# SERVICE BULLETIN

M-1206

## 2007 SPORTSTER ELECTRICAL DIAGNOSTIC MANUAL UPDATE

The purpose of this service bulletin is to inform you of updates and corrections to the 2007 Sportster Electrical Diagnostic Manual (Part No. 99495-07).

## Turn Signal Error 2B, Part 1 of 3

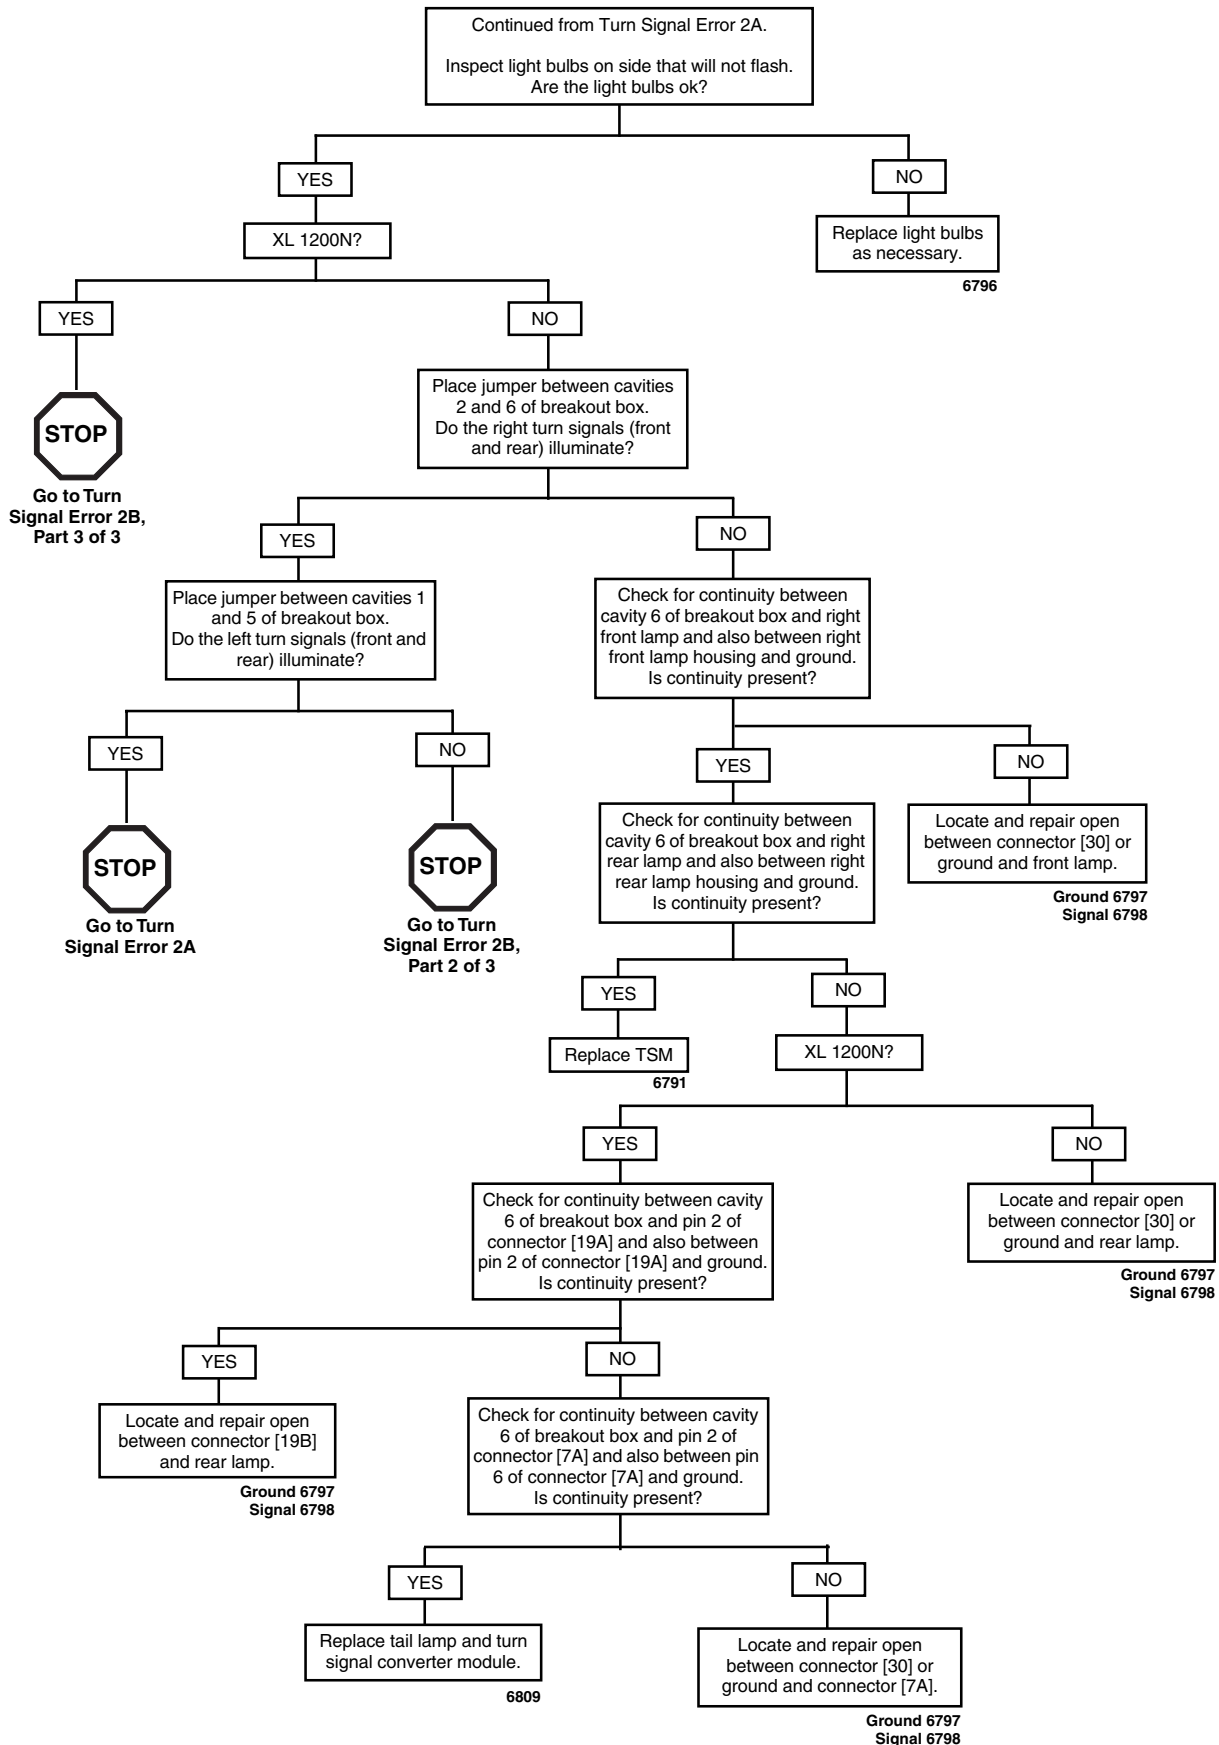
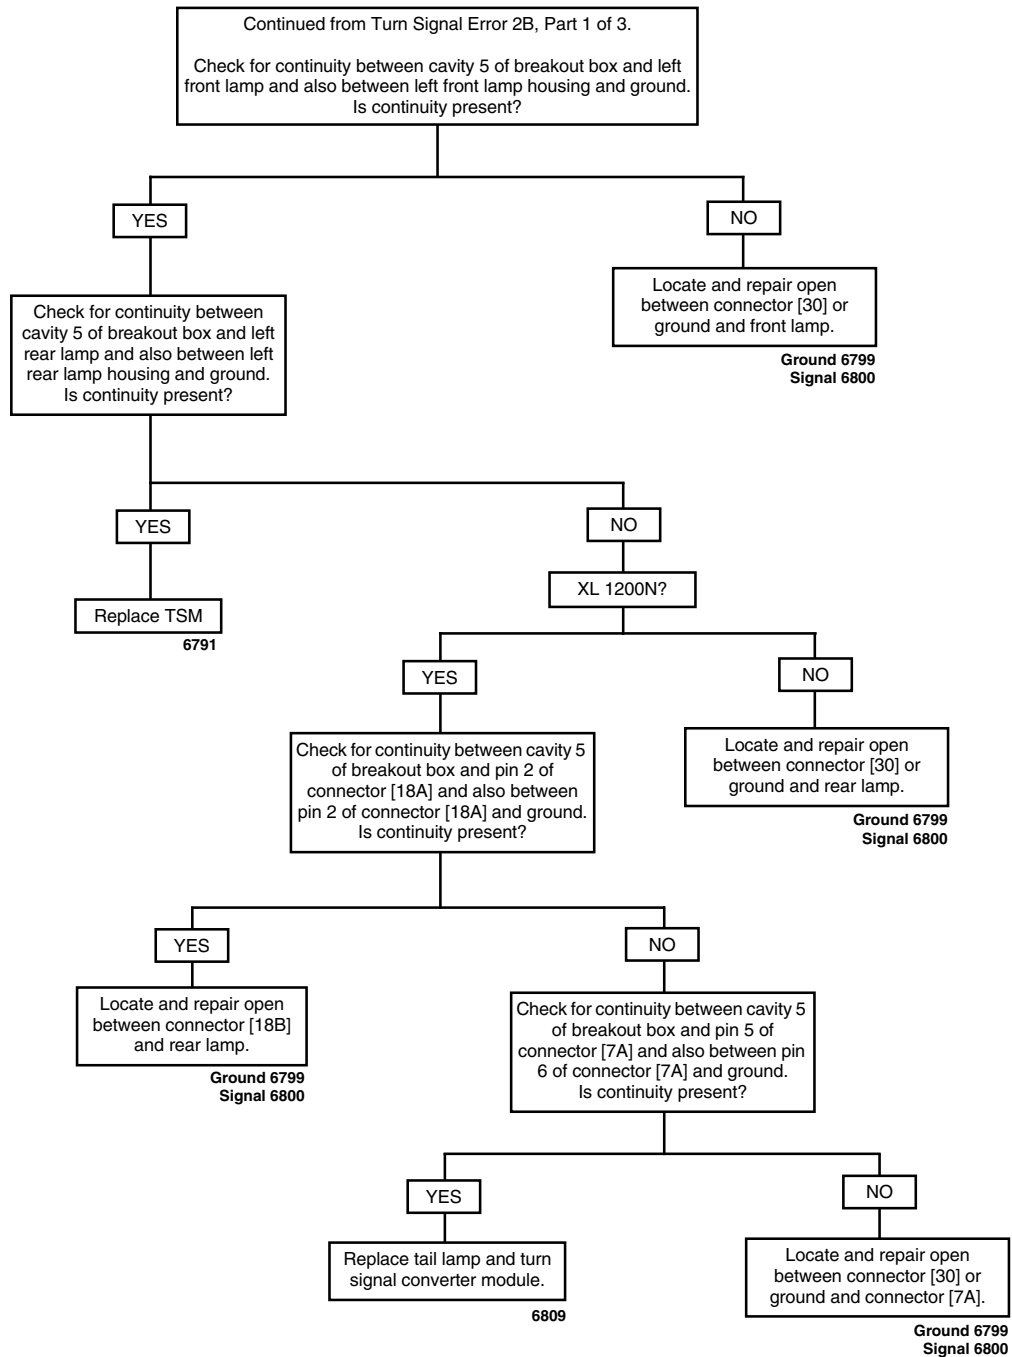
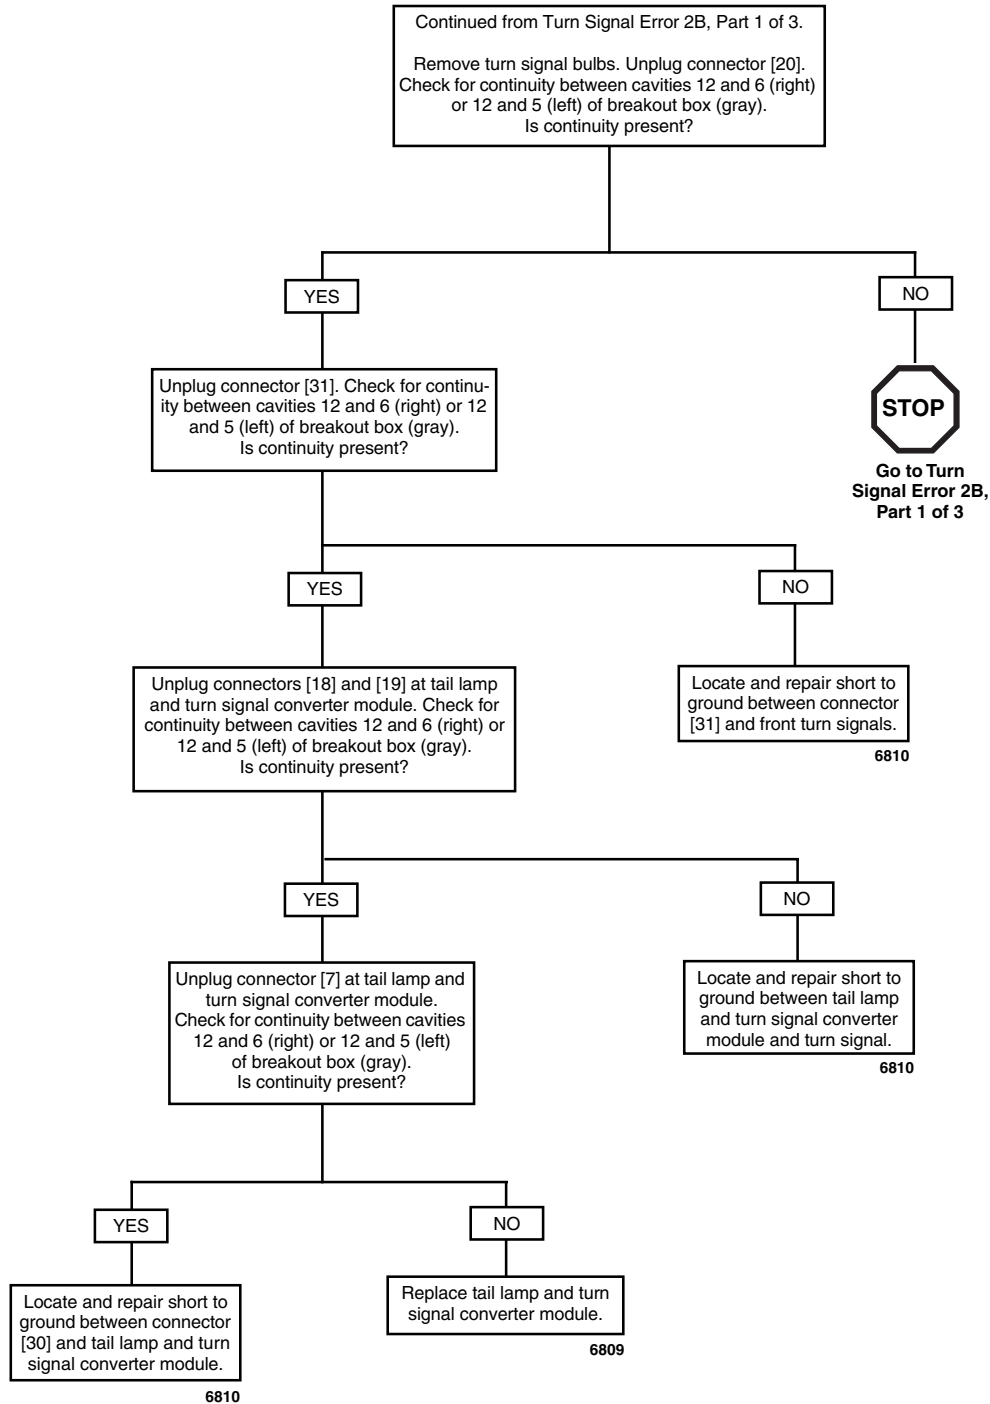
1. See Table 1-1, page 1-1. Change third item in left column from "Handlebar start switch" to "Handlebar start switch, clutch switch or neutral switch".
2. See Table 1-4, page 1-20. Add a row in the table and insert the following: under "ITEM", insert "ECM". Under "DRAW IN MILLIAMPS", insert "1.0".
3. See 3.7 SERVICE/EMERGENCY FUNCTIONS on page 3-14. Step 3 under TRANSPORT MODE should read as follows: "With an assigned fob within range, turn the ignition/headlamp key switch from IGNITION to ACCESS."
4. Rename "Turn Signal Error 2A" on page 3-41 to read, "Turn Signal Error 3A".
5. Replace page 3-42 (Turn Signal Error 3A (Part 1 of 4)) with "Turn Signal Error 2A" and its flow chart on page 5 of this document.
6. Replace page 3-43 (Turn Signal Error 3A (Part 2 of 4)) with "Turn Signal Error 2B (Part 1 of 3) through (Part 3 of 3)" and their flow charts on pages 6 through 8 of this document.

## Turn Signal Error 5A

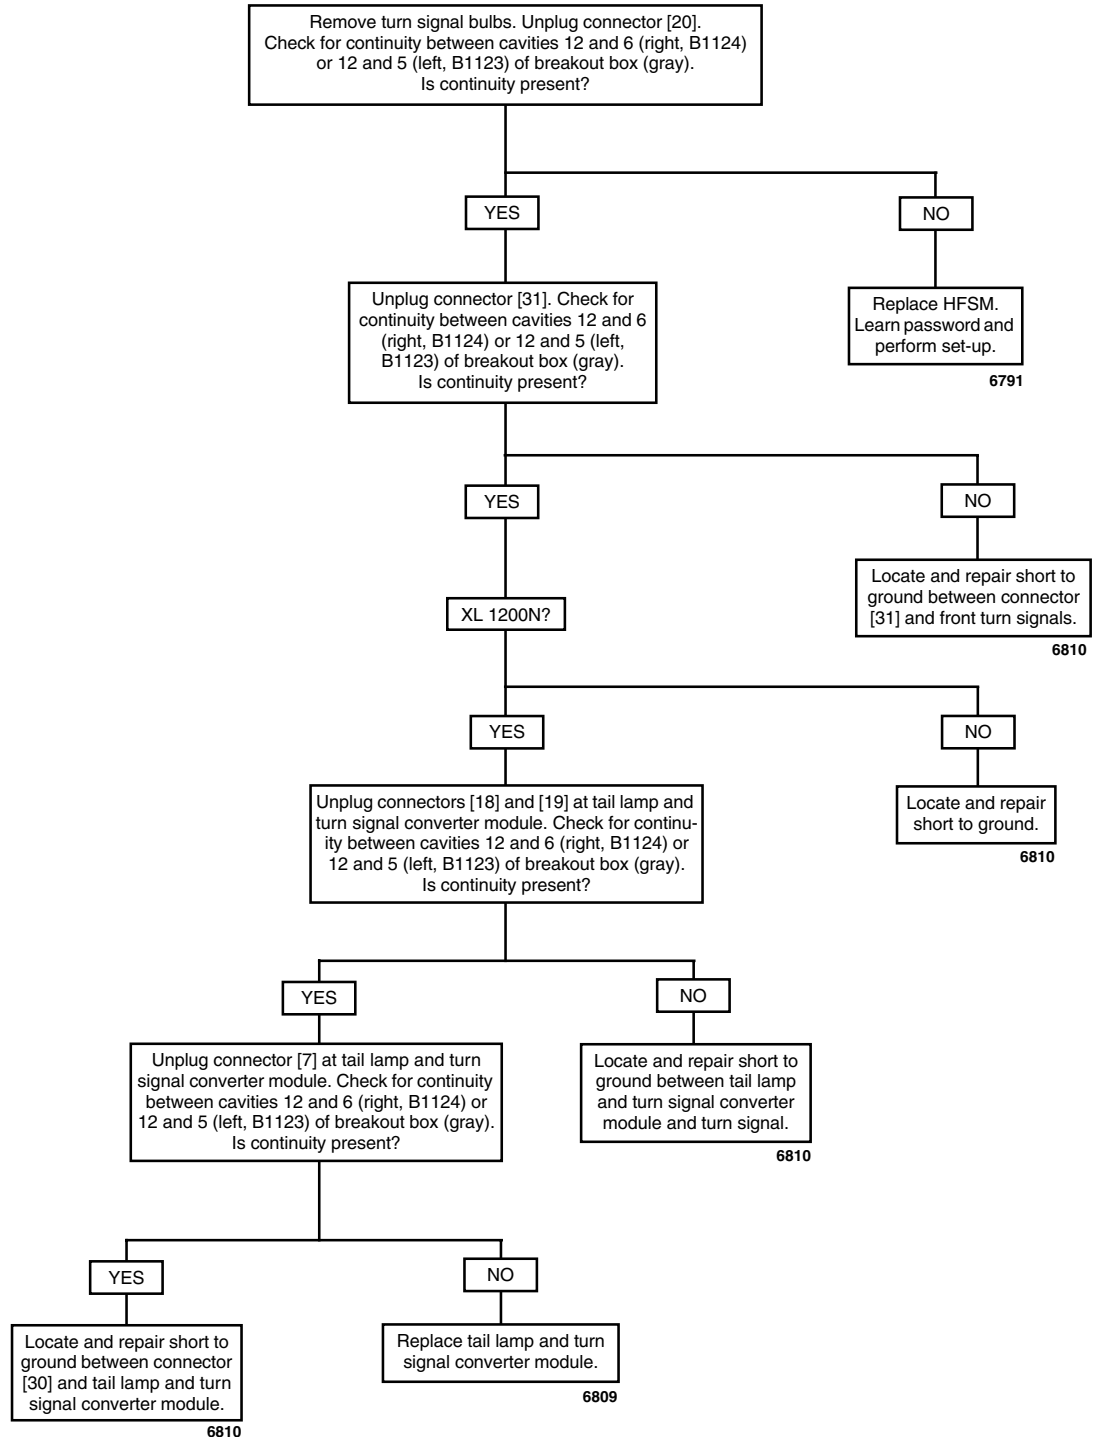
7. Rename "Turn Signal Error 3A (Part 3 of 4)" on page 3-44 to read, "Turn Signal Error 2C".
8. Rename "Turn Signal Error 3A (Part 4 of 4)" on page 3-45 to read, "Turn Signal Error 2D".
9. Replace page 3-47 (Turn Signal Error 5A) with "Turn Signal Error 5A" and its flow chart on page 9 of this document.
10. Replace page 3-48 (Turn Signal Error 6A) with "Turn Signal Error 6A" and its flow chart on page 10 of this document.
11. Replace Table 4-22 on page 4-69 with the table below:
